Work Order ID 149806 - 1 split

Item ID: D3394-041PHI

Item Name: Lug

DRAWING NO.	D3394	TITLE	REV. B	DART AEROSPACE LTD ENGINEERING ORDER	D.E.O. NO.	D3394-B-1	SHEET NO.	SHEET 1 OF 1	SCALE
DRAWN	AJS	CHECKED	MFG. APPR.	APPROVED	DE APPR.	DATE	09/11/04	DATE	09/11/04
DATE	09.11.04	DATE	09/11/04	DATE	09/11/04	DATE	09/11/04	DATE	09/11/04

SHEET 4 ZONE A,1 MODIFY SECTION A-A AS SHOWN:

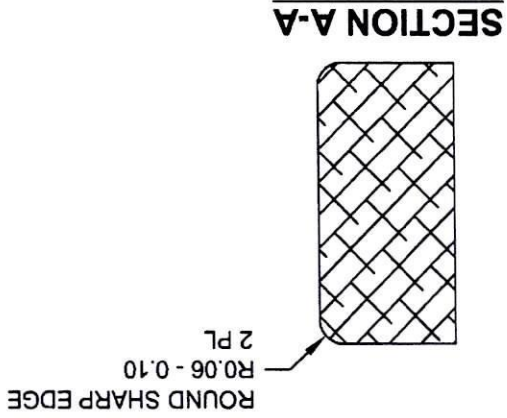
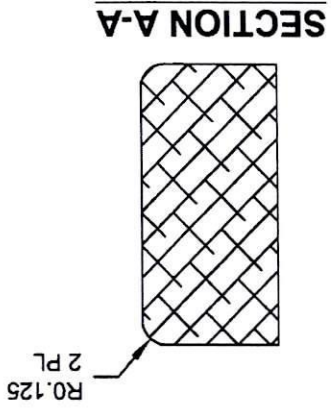
REASON: DRAFTING ERROR

IS:

D3394-1RG LUG (SHOWN)
D3394-3RG/-5RG LUGS (SIMILAR)
D3394-041RG/-043RG/-045RG LUG ASSEMBLIES (SIMILAR)

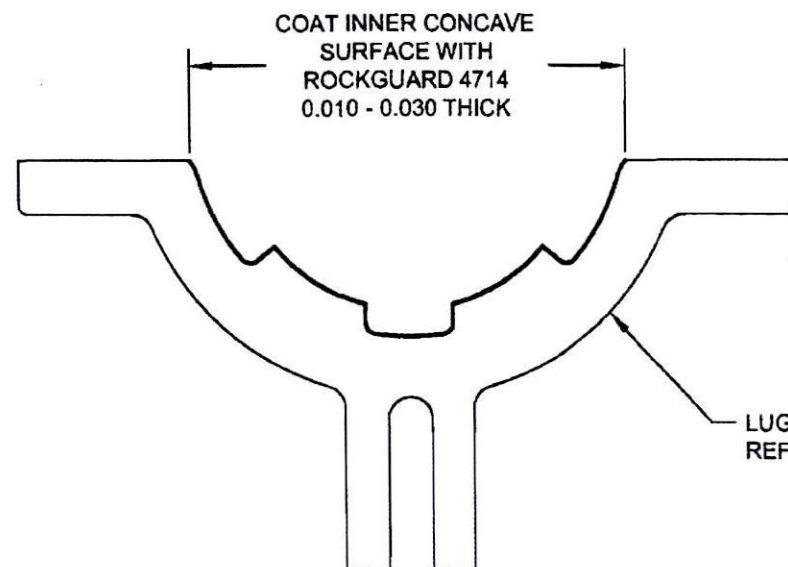
ADD D3394-xRG OPTION

D3394-xRG MOUNTING LUGS ARE IDENTICAL TO D3394-x MOUNTING LUGS, HOWEVER AFTER FINISH, COAT INNER CONCAVE SURFACE WITH "PLUS ONE ROCKGUARD 4714" AS SHOWN BELOW.
